GE Hitachi Nuclear Energy

MFN 08-086 Supplement 12

**Subject: Response to Portion of NRC Request for Additional Information
Letter No. 126 Related to ESBWR Design Certification Application,
RAI Numbers 14.3-228, 14.3-231, 14.3-232, 14.3-234, 14.3-381, and
14.3-382**

Figure 2.15.1-1. Containment System

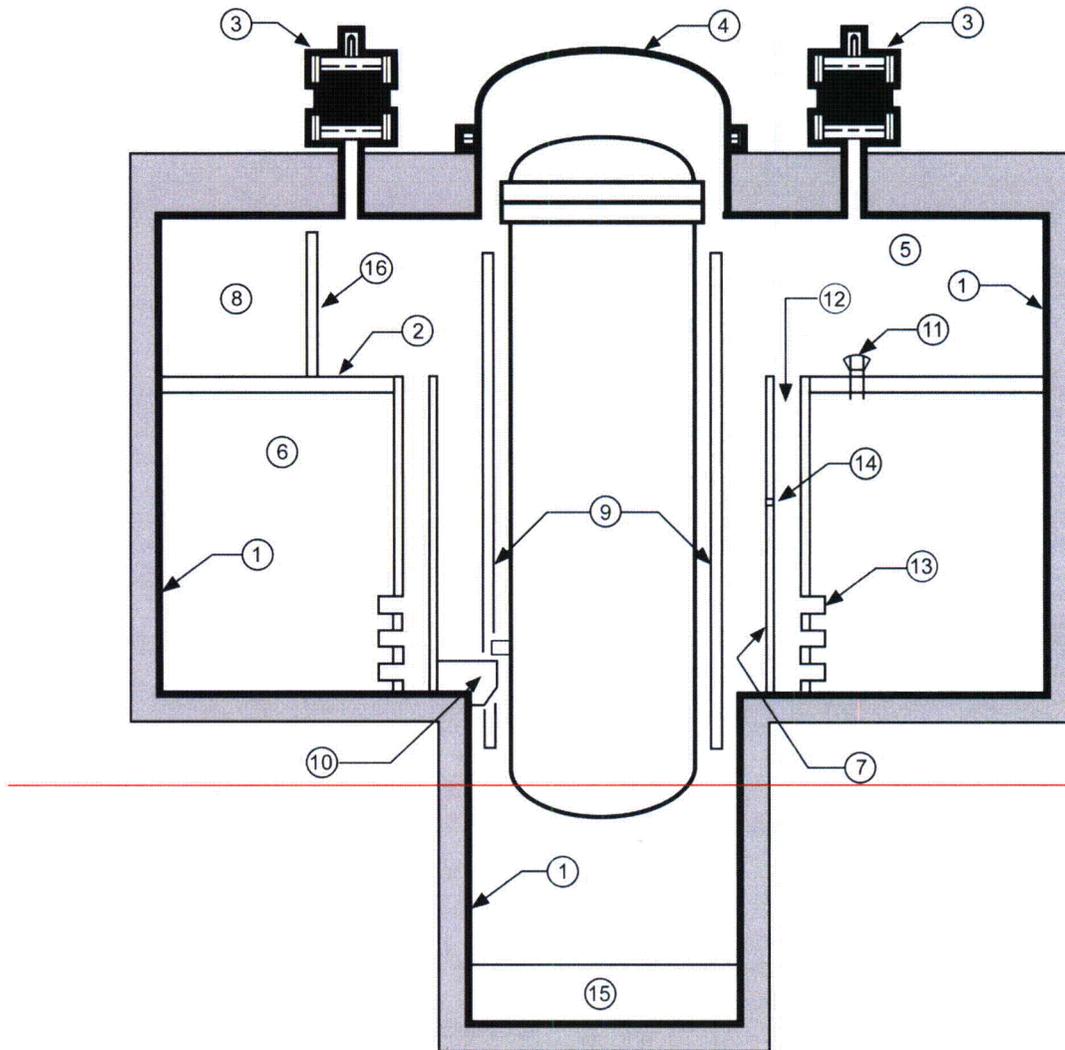
Please provide the following information in DCD Tier 1, Figure 2.15.3-1, to verify aspects of the containment analyses:

- (a) Vacuum breaker area in legend Item 11*
- (b) Total number of vertical vents in legend Item 12*
- (c) Relative elevation of spillover holes in legend Item 14.*

The following information will be incorporated in DCD Tier 1, Revision 4, Figure 2.15.1-1 "Containment System" as requested by the NRC. Figure 2.15.3-1 "Containment Internal Structures" will be updated to reflect only Containment Internal structures and will no longer include these components.

- (a) Vacuum breaker area: 0.2 m² each (ref: DCD Tier 2, Rev. 4, S6.2.1.1.4)
 0.6 m² (6.46 ft²) total
- (b) Total number of vertical vents: 12 (ref: DCD Tier 2, Rev. 4, Table 6.2-3)
- (c) Relative elev. of spillover holes: 12370 mm (ref: DCD Tier 2, Rev. 4, Fig. 3G.1-57)

DCD Tier 1, Figures 2.15.3-1, and 2.15.1-1, will be revised as noted in the attached markups.
